CONTRACT CHANGE ORDER

CCO 22	Suppl. No. 0	Contract No. 04 - 0120F4	Road SF-80-13.2/13.9	FED. AID LOC.:
--------	--------------	--------------------------	----------------------	----------------

SAN FRANCISCO OAKLAND BAY BRIDGE
EAST SPAN SEISMIC SAFETY PROJECT
SELF-ANCHORED SUSPENSION BRIDGE
(SUPERSTRUCTURE & TOWER)
CABLE TIE-DOWN DETAILS NO. 2

(For illustration only)
TIE-DOWN CABLE DETAILS
1:20

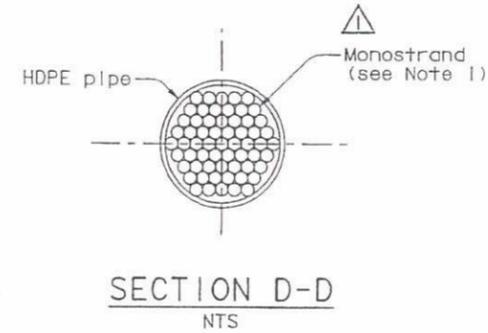
1. Revise Contract Plan Sheet Numbers 521, 629 and 651 (of 1204), with Contract Plan Sheet Numbers 521R1, 629R1 and 651R1 (of 1204), as shown in this change order.

MARK	DATE	DESCRIPTIONS	MN	NV
△	07/21/06	REMOVE EPOXY COATING		
			BY	CH'D

SECTION AT FLOORBEAM
 1:100

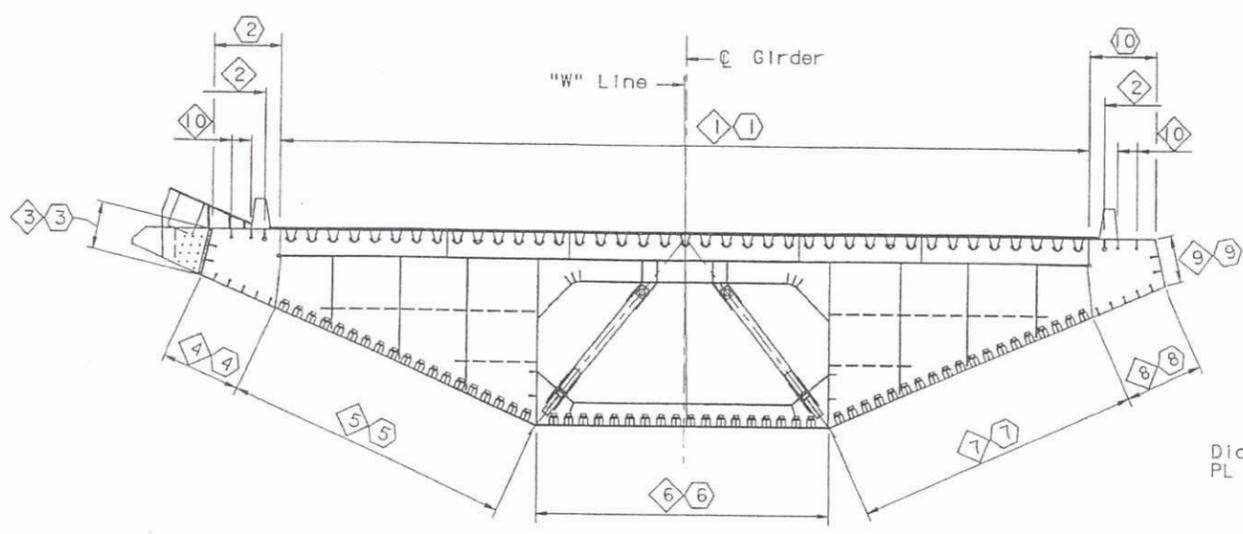
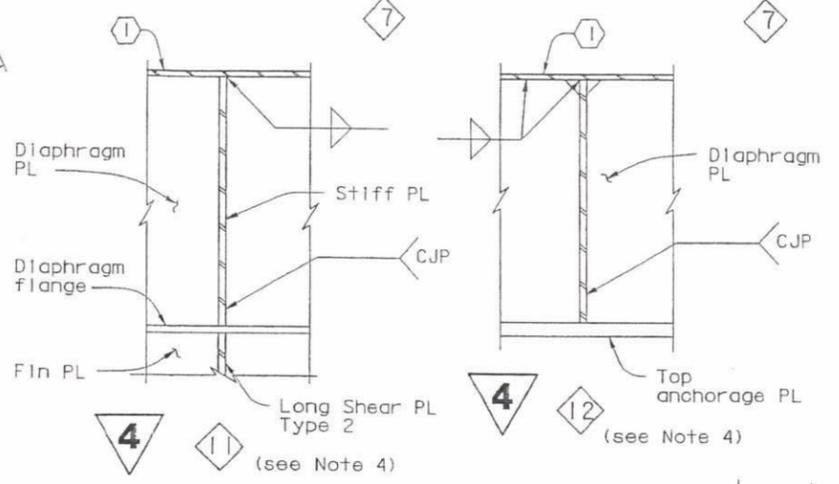
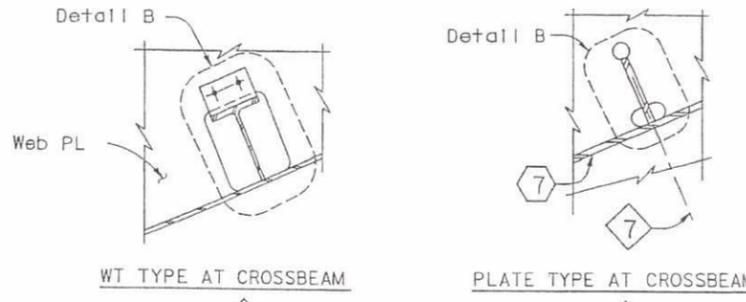
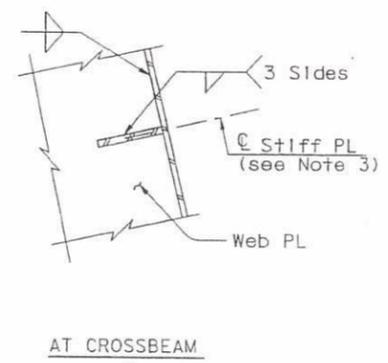
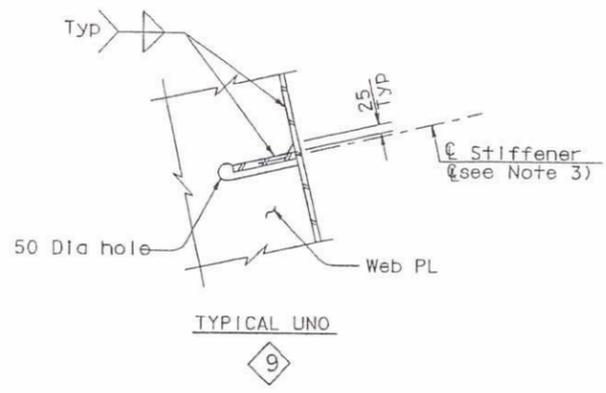
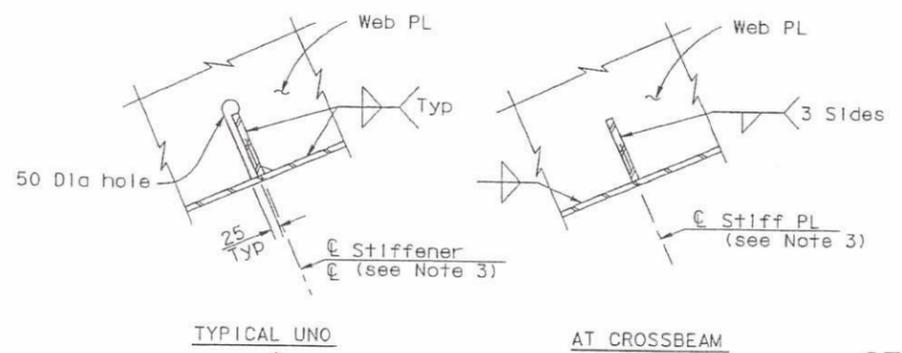
MARK	DATE	DESCRIPTIONS	BY	CH'D
▲	07/21/06	ADD STIFFENER TYPES 13 THRU 18	GB	NV
		REVISIONS

TYPICAL FLOORBEAM DETAILS NO.6

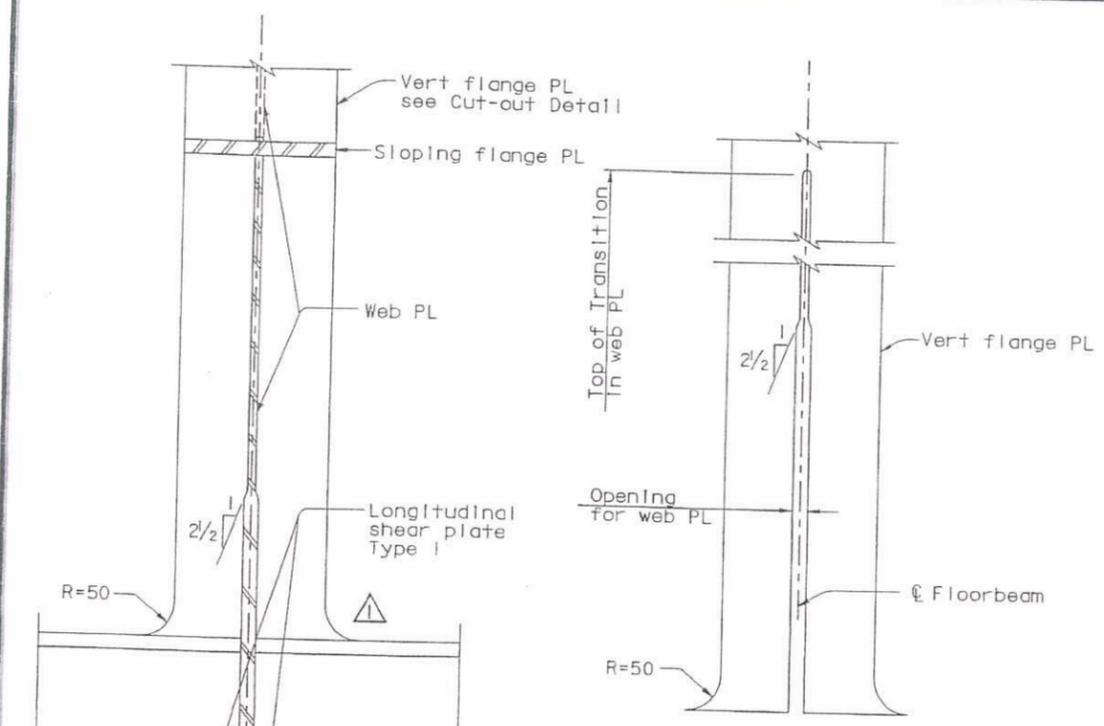
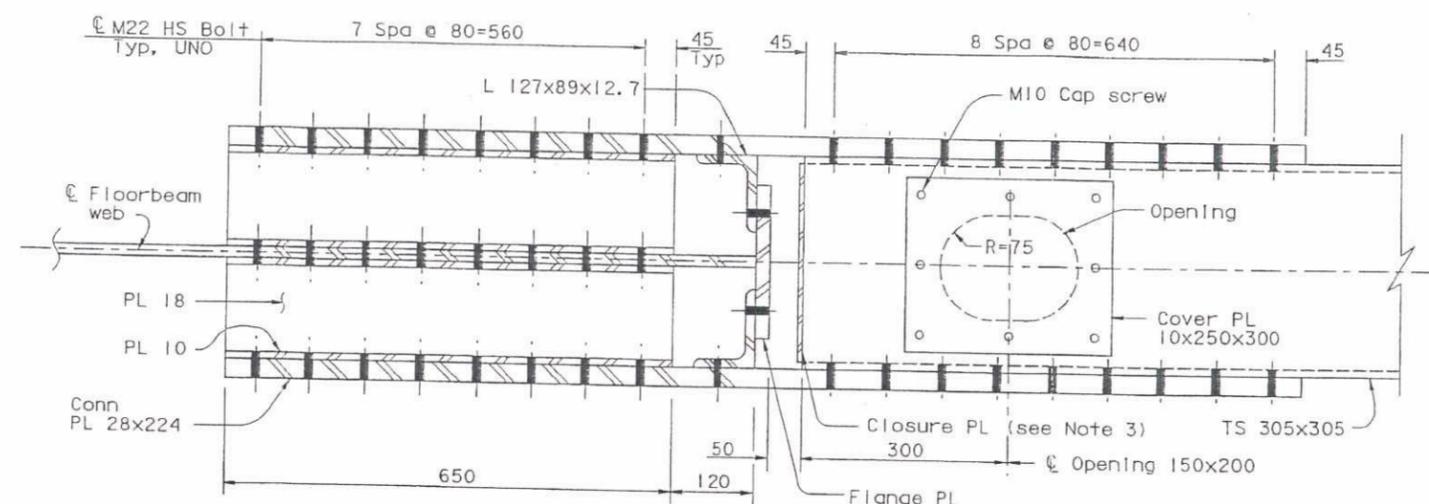
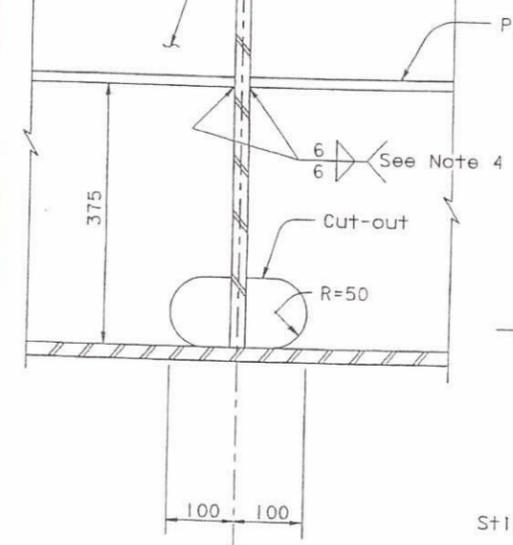
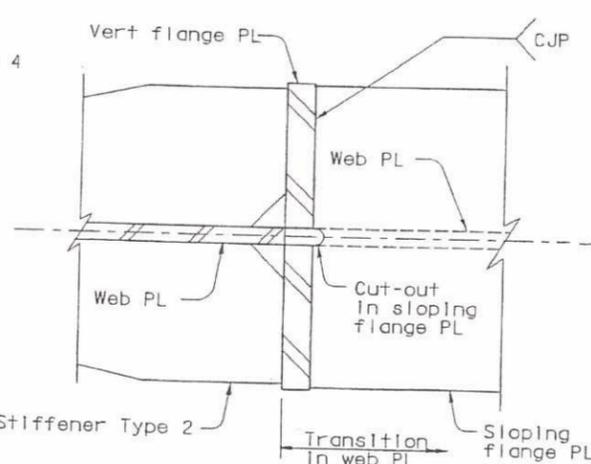
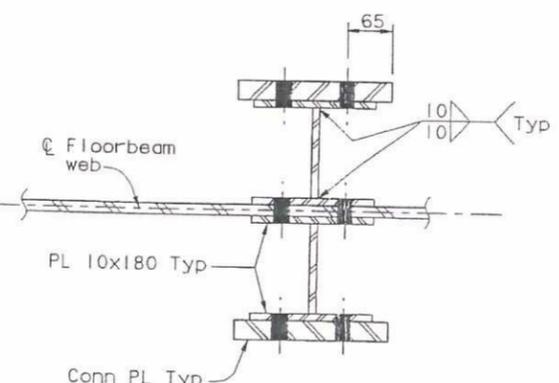
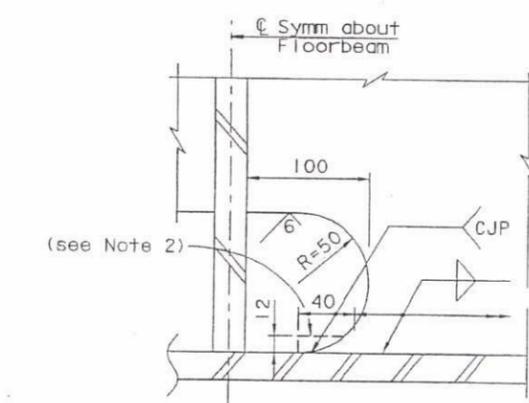
MARK	DATE	DELETES WELD CALLOUT	GB	NV
		DESCRIPTIONS	BY	CH'D
